Nebraska Public Power District

NLS2004005
January 29, 2004

Subject: License Amendment Request to Revise Technical Specification 3.4.9 Pressure Temperature (P/T) Curves figures 3.4.9-1, 3.4.9-2, and 3.4.9-3.
Cooper Nuclear Station, Docket 50-298, DPR-46

Cooper Nuclear Station, NRC Docket 50-298, DPR-46

Figure 3.4.9-1 (page 1 of 1)
Temperature/Pressure Limits for
Non-Nuclear Heatup or Cooldown Following Nuclear Shutdown

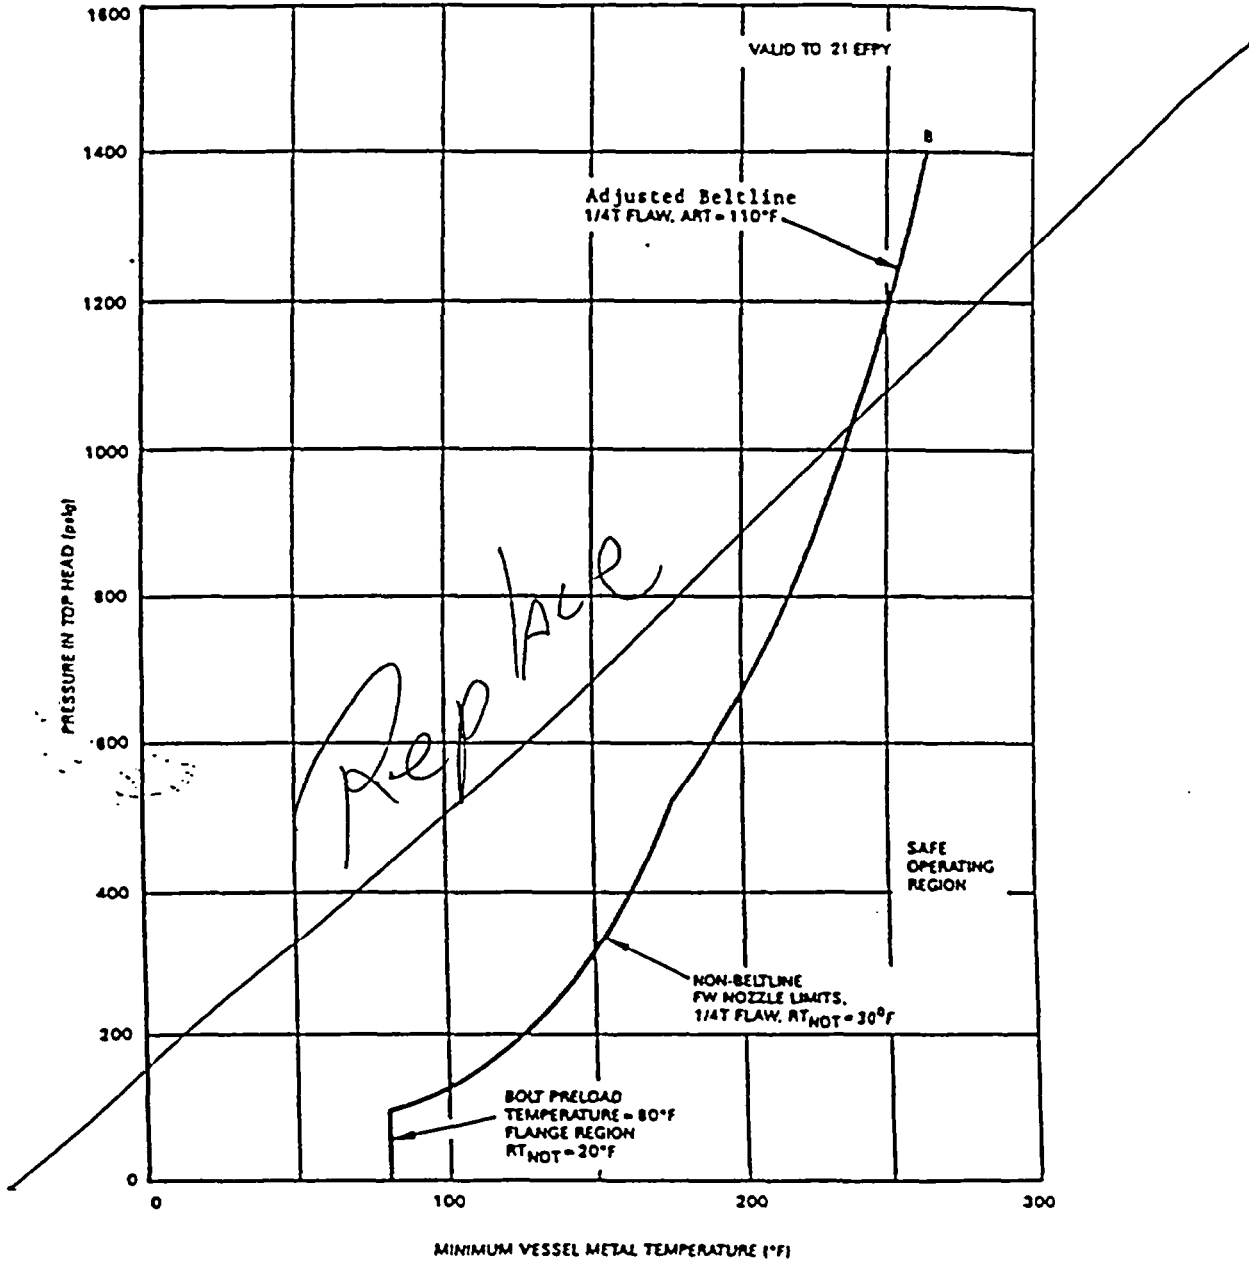
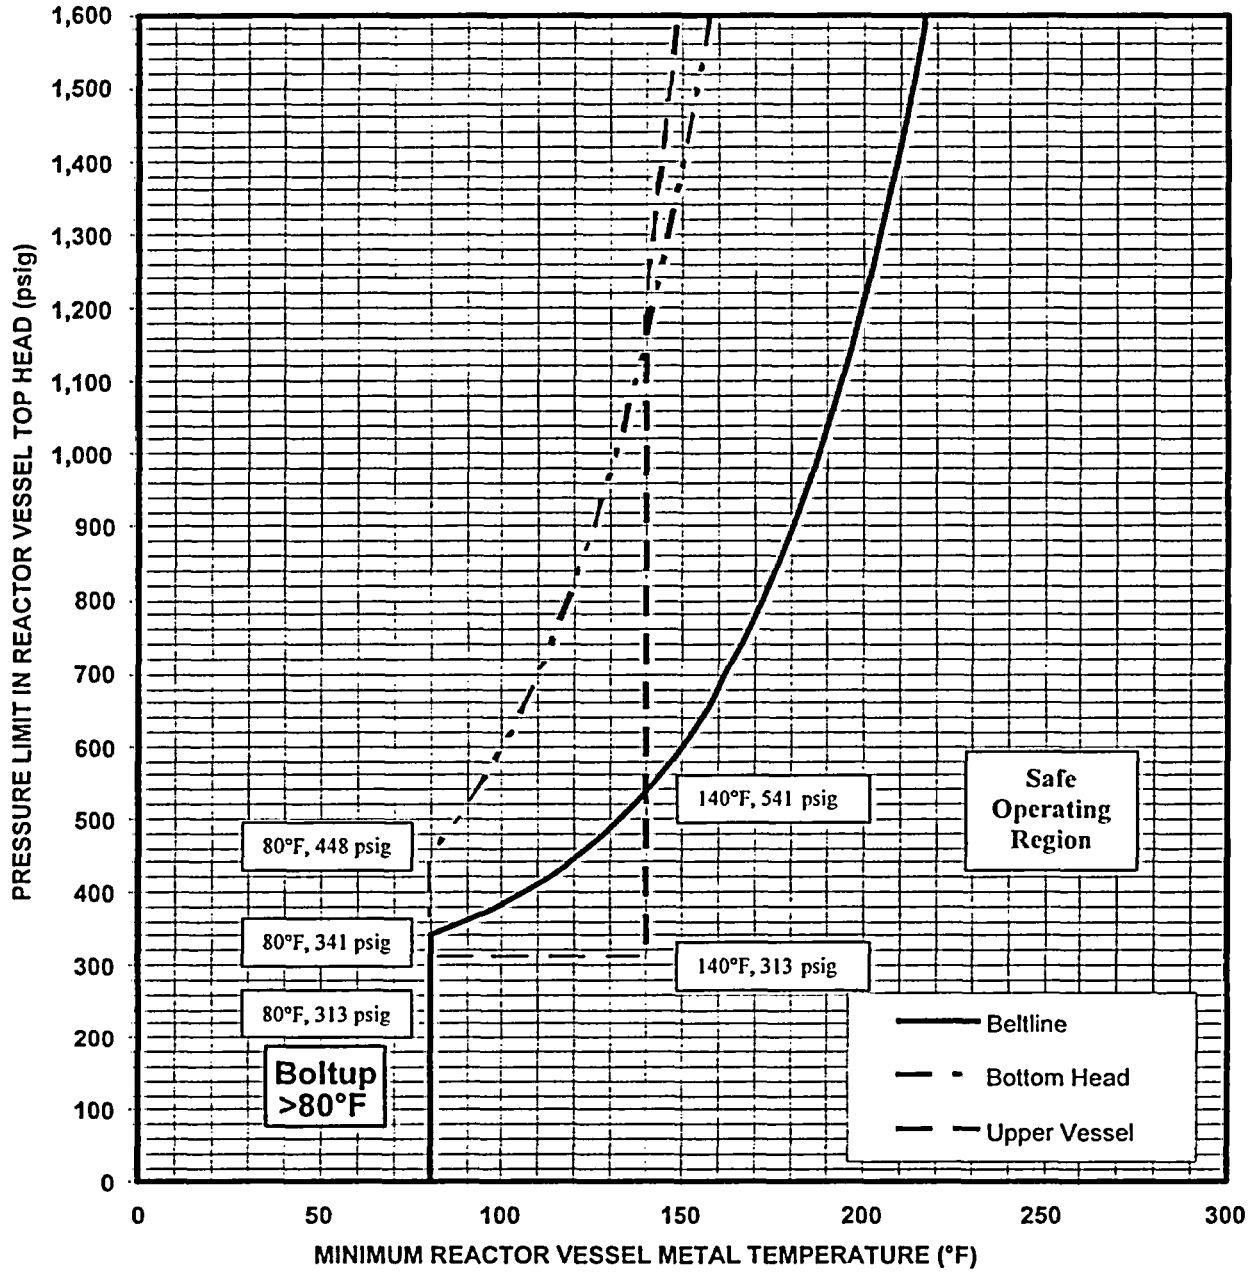
This proposed change will revise TS 3.4.9 P/T curves, figures 3.4.9-1, 3.4.9-2, and 3.4.9-3, to allow plant operation from 21 EFPY through 32 EFPY. The proposed amendment includes a full set of updated P/T curves for pressure test, core not critical and core critical conditions. The three regions of the reactor pressure vessel that are evaluated are the beltline region, the bottom head region, and the feedwater nozzle/upper vessel region. These regions bound all other regions with respect to brittle fracture. The P/T curve limits are developed according to Appendix G of ASME Boiler and Pressure Vessel Code, Section XI. ASME Section XI Code Case N-640 was used in the development of the P/T curves. There are two lower bound fracture toughness curves available in Section

The P/T curves for the CNS beltline, bottom head, and upper vessel regions have been updated. Heatup/Cooldown curves were developed for 32 EFPY. The curves revised were developed in accordance with the requirements of 10 CFR 50 Appendix G. The methods in the 1995 Edition, 1996 Addenda of ASME Code, Section XI, Appendix G were used with ASME Section XI Code Case N-640, "Alternative Reference Fracture Toughness for Development of P-T Limit Curves." Regulatory Guide (RG) 1.147, Revision 13, identifies ASME Section XI Code Case N-640 as a Nuclear Regulatory Commission (NRC) acceptable ASME Section XI code case. ASME Section XI Code Case N-640 was also used in the development of the P/T curves approved by the NRC staff for Susquehanna Units 1 and 2. The new P/T curves for CNS and Susquehanna were developed by Structural Integrity Associates.

There are three regions that were evaluated: (1) the beltline region, (2) the bottom head region, and (3) the feedwater nozzle/upper vessel region. The methodology used to calculate the heatup/cooldown P/T curves for each of these regions is summarized in the following subsections:

The temperature at the assumed flaw tip, T_{1/4t} (i.e., 1/4t into the vessel wall), was conservatively assumed to be zero and the metal temperature was assumed equivalent to the fluid temperature. The CNS temperature gauge has an uncertainty of +/- 5°F. A temperature 5°F less than the initially assumed fluid temperature was used to calculate the allowable pressure, producing a lower allowable pressure, and therefore making the calculation conservative.

If the calculated pressure, P , is greater than 20% of the pre-service hydro test pressure, the temperature must be greater than RTNDT of the limiting flange material + 120°F. The pre-service hydro test pressure was 1,563 psig, and the limiting flange material has an RTNDT of 20°F.

Cooper Heatup/Cooldown, Core Not Critical Curve (Curve B), 32 EFPY

Figure 3.4.9-2 (page 1 of 1)
Temperature/Pressure Limits for
Inservice Hydrostatic and Inservice Leakage Tests

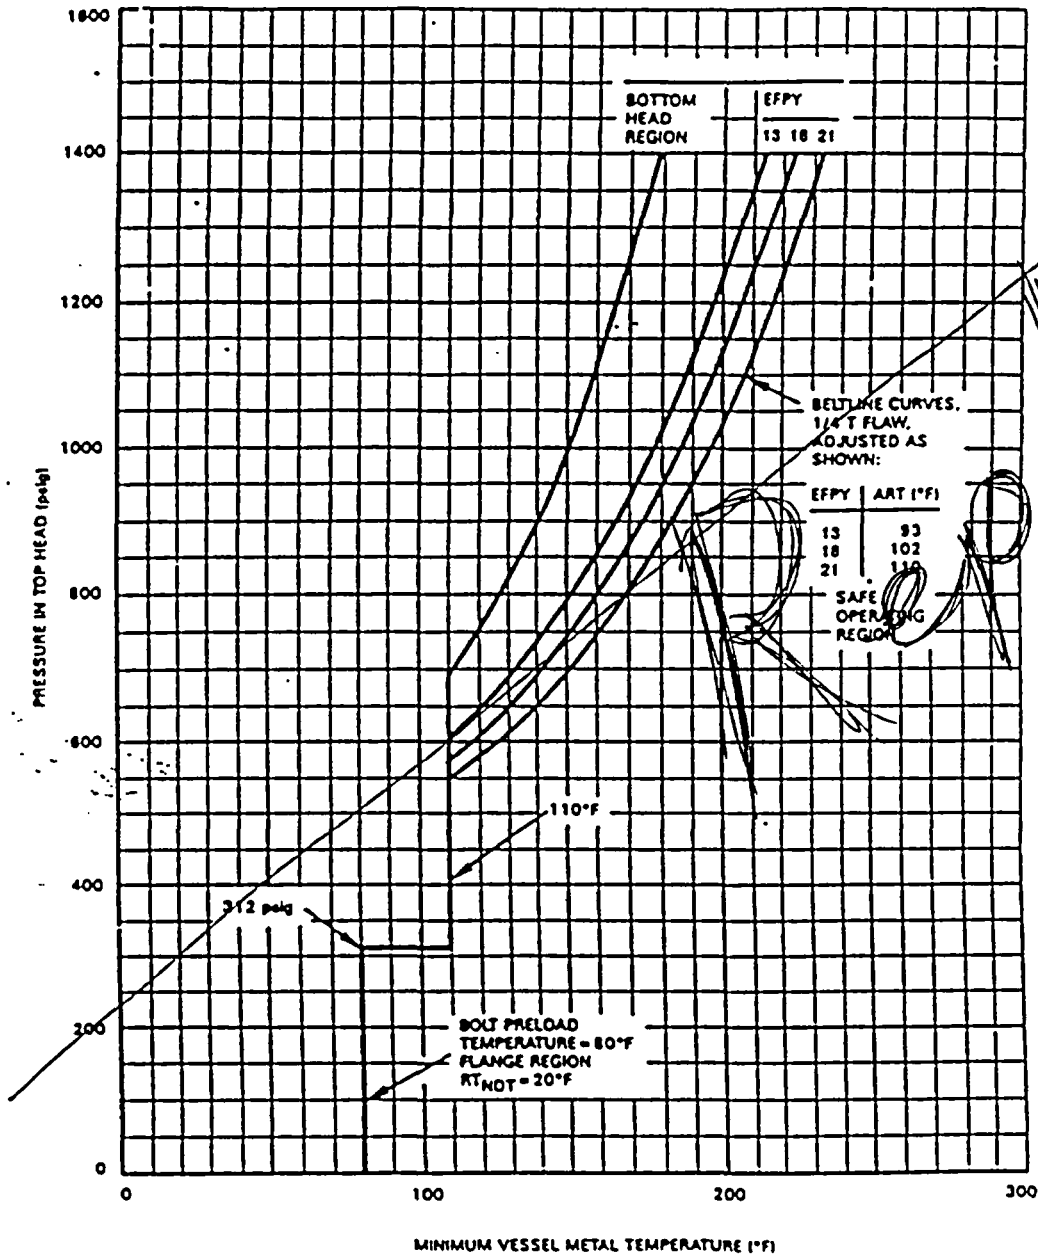
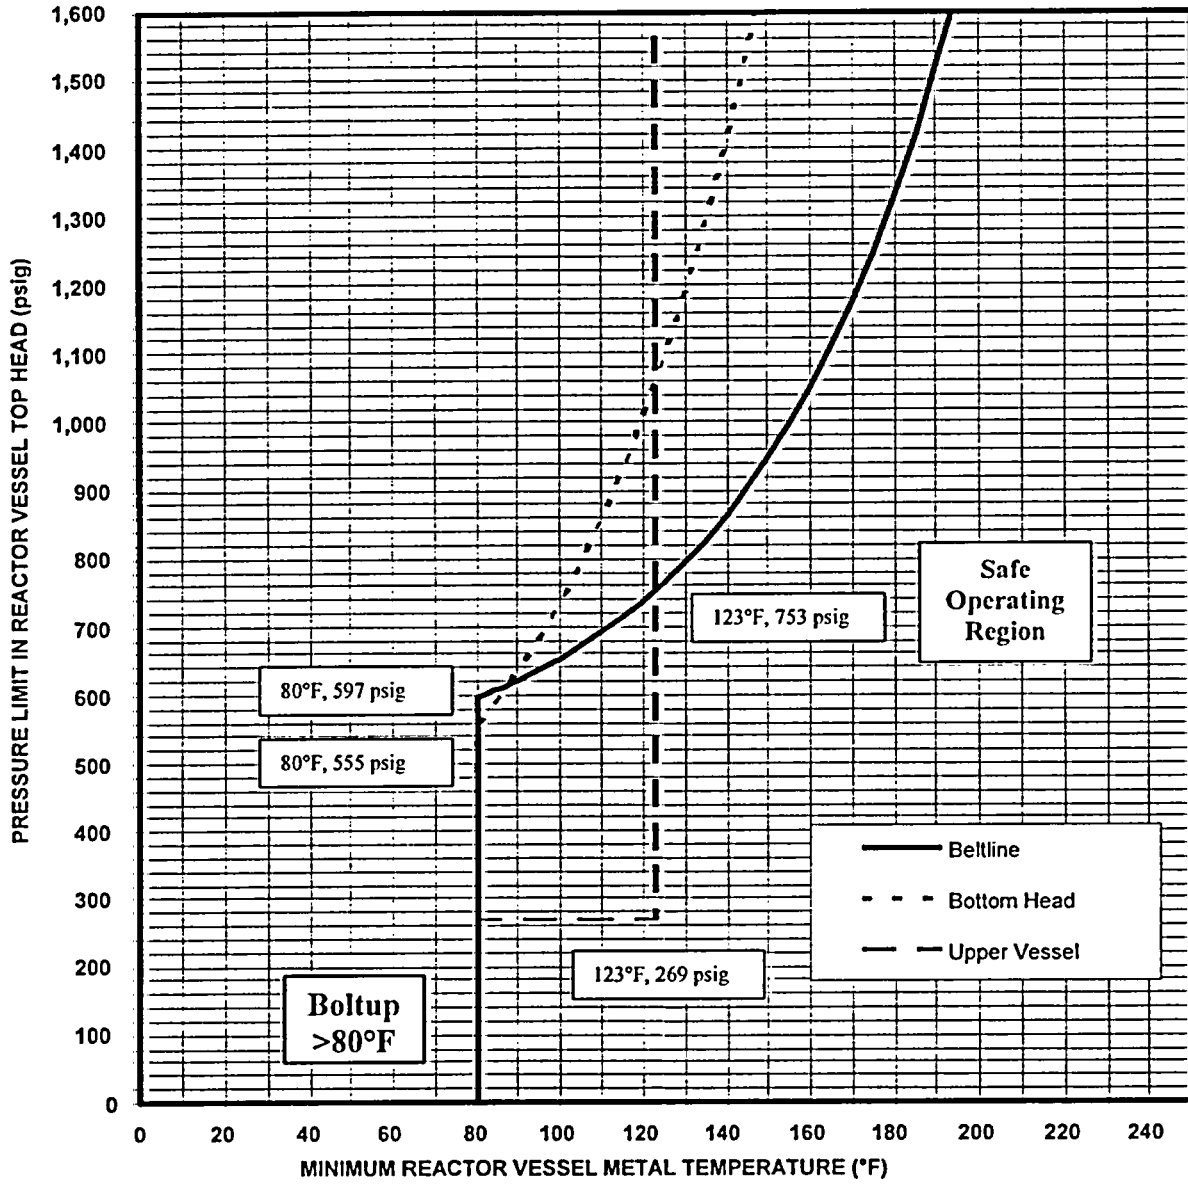
CURVE A (DEVELOPMENT OF UPDATED PRESSURE TEST P/T CURVES)

Three regions were evaluated: (1) the beltline region, (2) the bottom head region, and (3) the feedwater nozzle/upper vessel region. The approach used for calculating the pressure test P/T curves for each of these regions is summarized in the following subsections.

The temperature at the assumed flaw tip, $T_{1/4t}$ (i.e., 1/4 thickness into the vessel wall), is equal to the fluid temperature, as the pressure test condition neglects any thermal effects. The assumed temperature that is read on the plant's gauge has an uncertainty of $\pm 5^\circ\text{F}$. A temperature 5°F less than that assumed is used for calculating the allowable pressure. This method produces a lower allowable pressure, making it conservative.

If the calculated pressure, P , is greater than 20% of the pre-service hydro test pressure, the temperature must be greater than RTNDT of the limiting flange material + 90°F . The pre-service hydro test pressure was 1,563 psig, and the limiting flange material has an RTNDT of 20°F .

Cooper Pressure Test Curve (Curve A), 32 EFPY

Figure 3.4.9-3 (page 1 of 1)
Temperature/Pressure Limits for Criticality

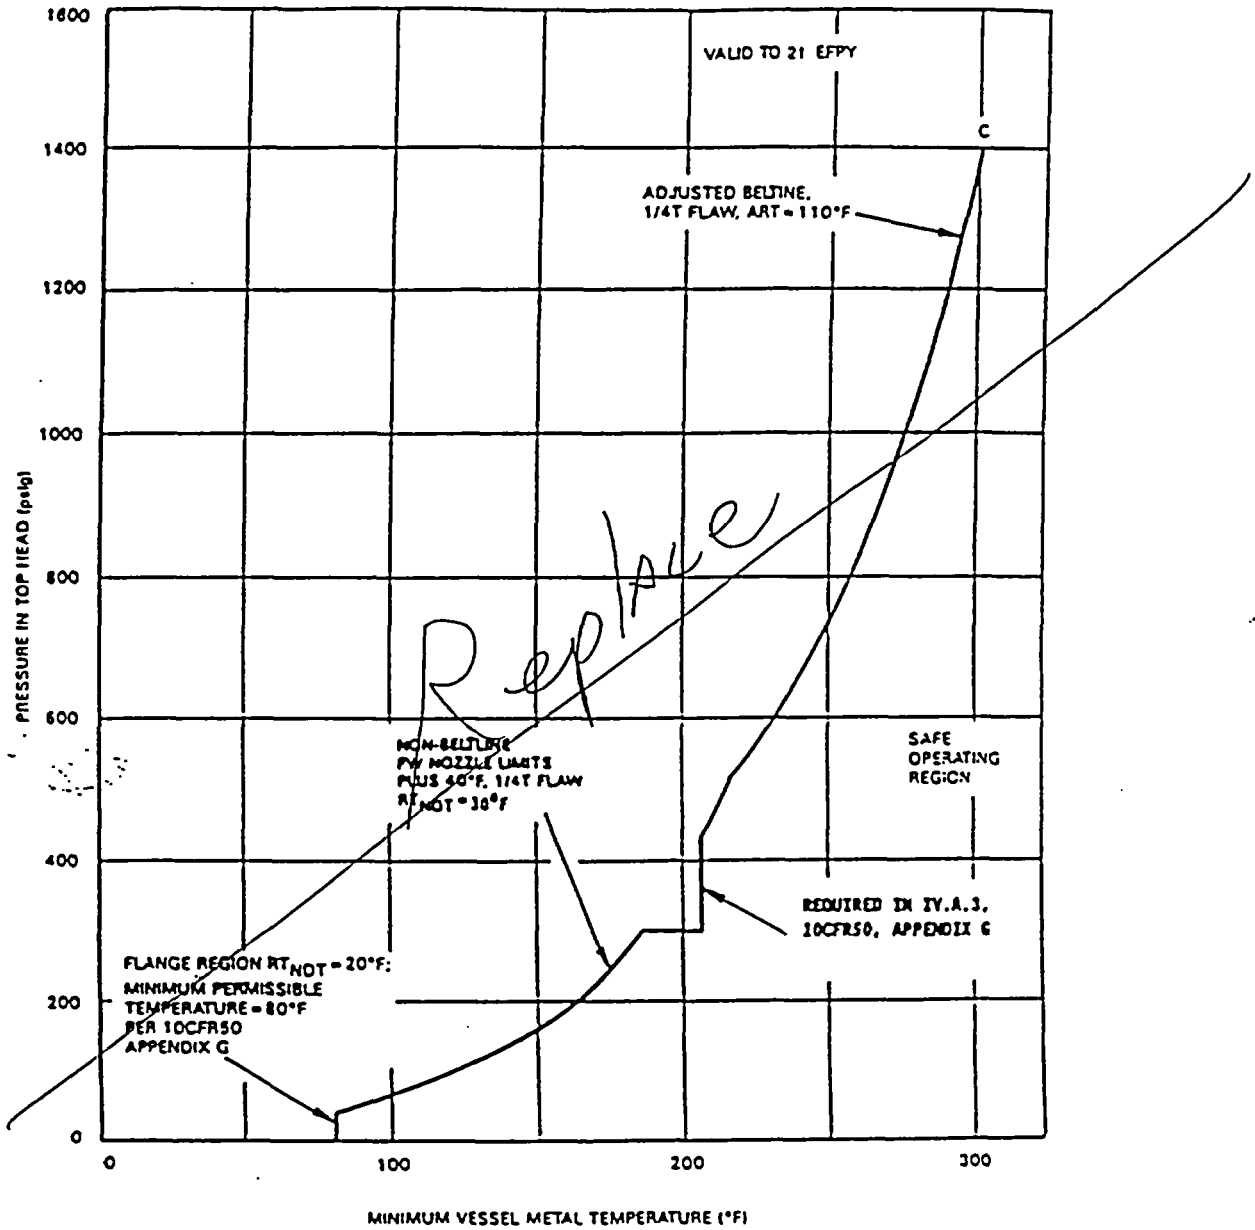
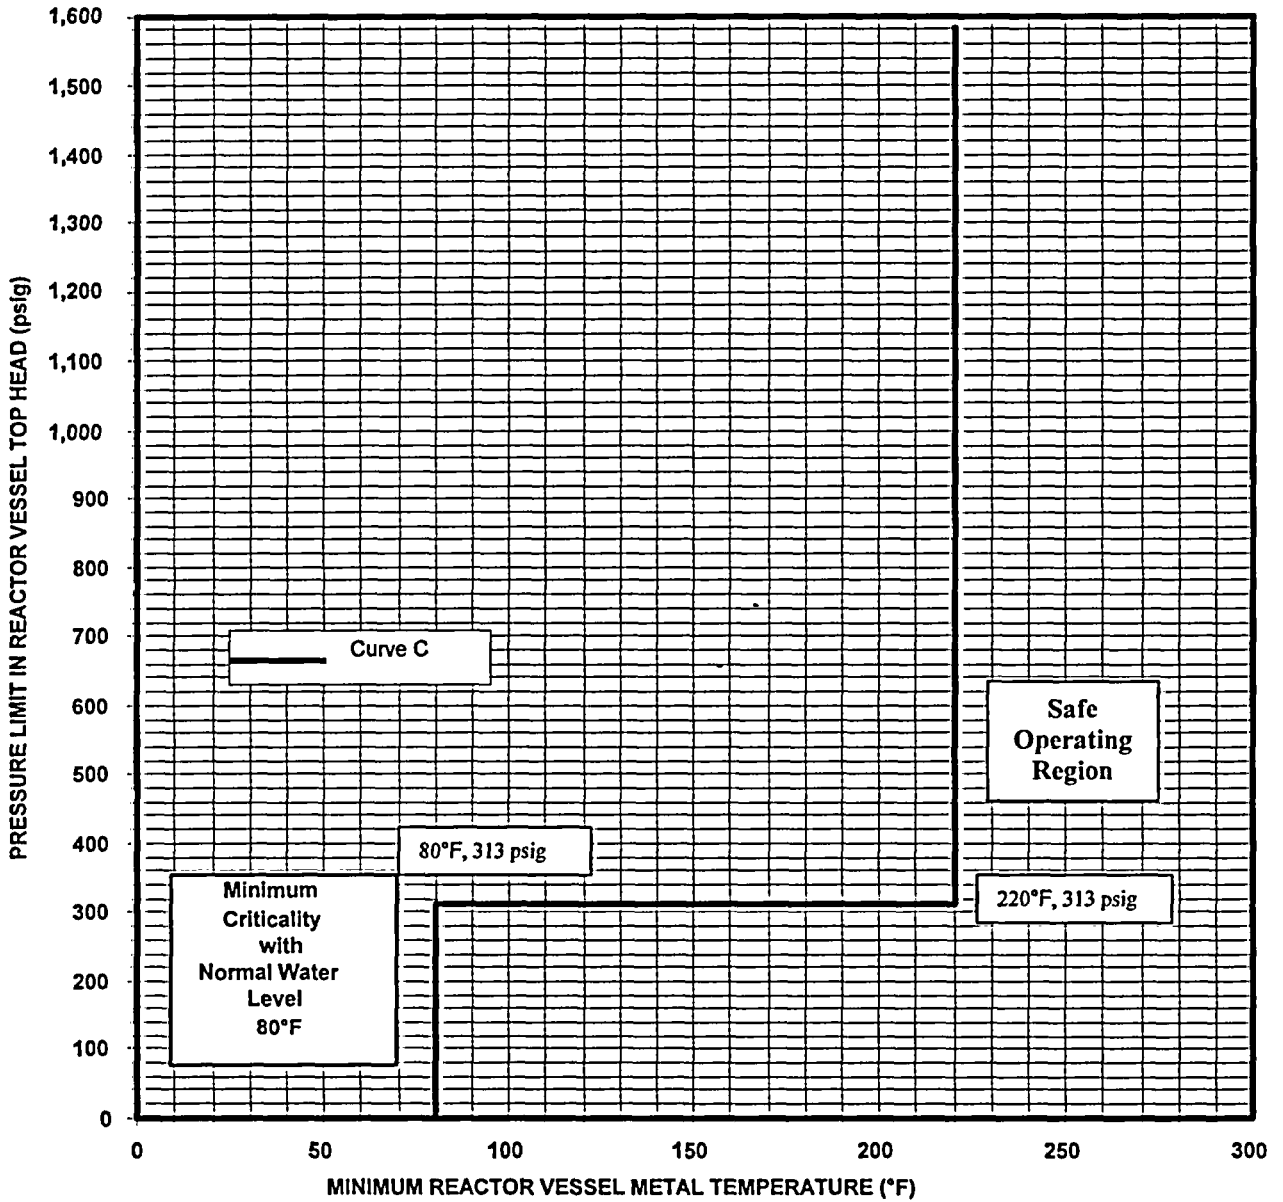
Curve C, the core critical operation curve, is generated from the requirements of 10 CFR 50 Appendix G. Table 1 of Appendix G requires that core critical P/T limits be 40°F above any Curve A (Updated Pressure Test) or B (Heatup/Cooldown, Core not Critical) limits when pressure exceeds 20% of the pre-service system hydrostatic test pressure. Curve B is more limiting than Curve A, so limiting Curve C values are equal to Curve B plus 40°F for pressures above 312 psig.

Cooper Heatup/Cooldown, Core Critical Curve
(Curve C), 32 EFPY
